1.I. New And Old Business Packet For 5/26/20

Sconset Advisory Board *Meeting Memorandum* **HDC/SAB**

Date: 5/26/2020 Address 33 COFFIN STREET

Scope of Work: RENOVATION DECKS + BALCONY + WINDOWS

"EXHIBIT A"

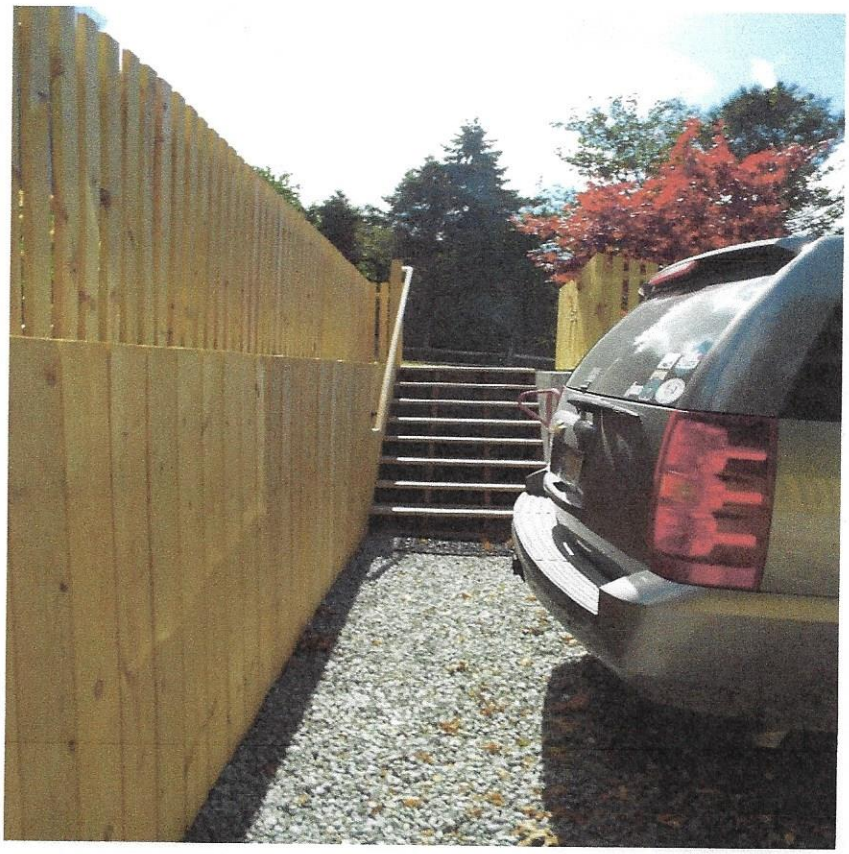
10. THE ISSUES:
    a. The north and south walls were put in rather than berms.
    b. The rear wall has to be parged, all walls with be parged to smooth them out as is common on the island.
    c. The rear wall also has to be screened.
    d. The fence had to be added after the approval in August 2017.

THE REAR WALL WAS APPROVED AS WELL AS SHOWN, BUT TO BE PARGED. COMMENTS WERE MADE THAT THE REAR WALL HAD TO BE SCREENED SOMEHOW. APPLICANT FIRST DID THIS AND THEN REMOVED IT SO IT COULD BE PARGED. IF THIS IS AN ACCEPTIBLE SOLUTION, HE WOULD PUT THE BOARDS BACK ON THE REAR WALL. OTHERWISE, CLIMBERS WOULD BE PLANTED ON THE TOP AND PULLED DOWN THE WALL. NO PLANTING BED WOULD SURVIVE IN THE PARKNG AREA AS IT ONLY HAS ABOUT TWO EXTRA FEET OUTSIDE OF WHAT IS REQUIRED FOR A LEGAL PARKING SPACE AND WOULD BLOCK THE STAIRWAY UP TO THE HOUSE AS THAT IS AGAINST THE BACK WALL. ONLY SOLUTION IS TO EITHER DO THIS TREATMENT, ALLOW IT TO BE PARGED, OR REQUIRE CLIMBERS FROM THE TOP.

11. PLAN:
    a. The fence will be pulled back from the street on the north and south sides to the 30-inch point of each wall. It is 8.5 feet on the north and 6 feet on the south.

b. A treatment, as approved by the HDC, will be done to the rear wall, either the vertical wood slats put back, left natural with parging (all walls parged), climbers planted from the upper level to grown down over the wall, or horizontal landscape timbers. Once parged grey the walls should be less impactful.
